V5 final plan, before the CAD

Your two questions first, then the plan I will build V5 from. Concept numbers, not yet in CAD.

Final stack, nose up (concept, to scale). The airbrake section is one BT80 tube cut once; the module sits on the transition top; the head sits on the module; the section opens at its top.

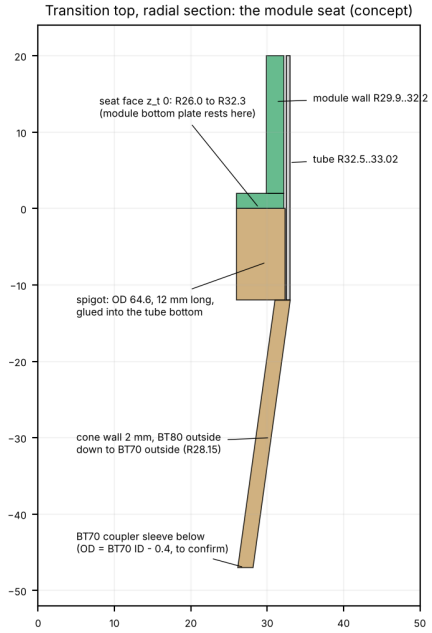
You are right about the stack, and it corrects my V4 drawing. The airbrake's BT80 tube sits **directly on the transition**, and the transition tapers down to the BT70 tube below it. In V4 I had drawn a lower BT80 tube with a flat ring bonded inside it; there is no lower BT80 tube. What I called the transition ring is really the top of the transition. BT80 is 66.04 mm outside and 65.02 mm inside (Estes listings); BT70 is 56.3 mm outside (2.217 in); I could not confirm the BT70 inside diameter, which I need for the lower sleeve of the transition.

The transition top: spigot glued into the tube bottom, seat face under the module, cone down to BT70. The cone length and the BT70 sleeve are placeholders.
